LUSCOMBE AIRPLANE CORPORATION
P.O. Box 2128, Dallas 1, Texas

SERVICE BULLETIN NO. 3-47

SUBJECT: Inspection of Fin, Rear Spar Attachment Fitting

Model 8 Series

VIEW A FULL SIZE

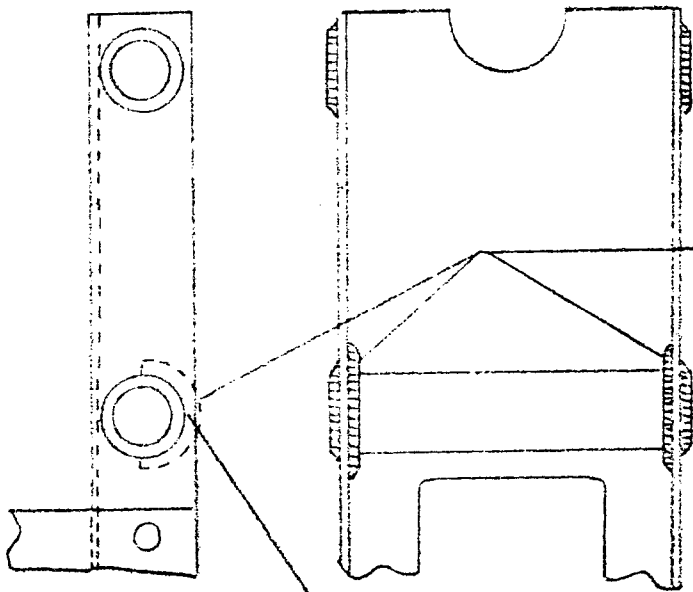
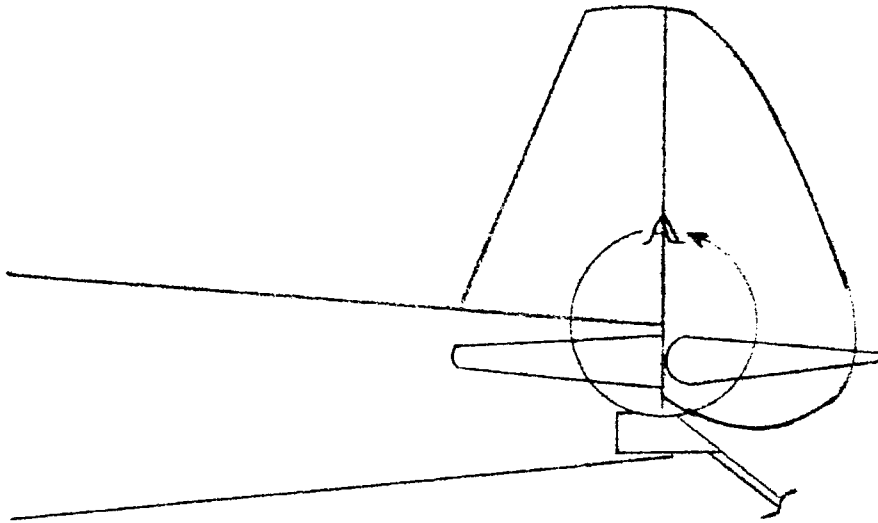
Upon receipt of this Service Bulletin an inspection should be made of the rear fin (vertical stabilizer) attachment fitting for evidence of cracks in the flange of the fitting adjacent to the 3/8" bushing welded across the web between the flanges.

If an inspection does or does not reveal a crack or fracture in the areas as indicated per the attached sketch the fitting should be reworked immediately in accordance with the rework instructions. If the cracks are found to have progressed further than indicated on the sketch the fitting should be replaced.

LOCATION OF POSSIBLE CRACK

1. Remove Rudder and Fin from Airplane.
2. Remove Fitting from rear Spar and remove paint.
3. Weld half of AN960-616 Washer, or equivalent as shown in sketch.
4. Prime and repaint Fitting.
5. Reassemble to Spar
6. Reinstall Fin and Rudder.
7. Indicate compliance with this Bulletin by suitable entry in Aircraft Log Book.

ONE HALF AN 960-616
WASHER WELDED TO
18419 FITTING
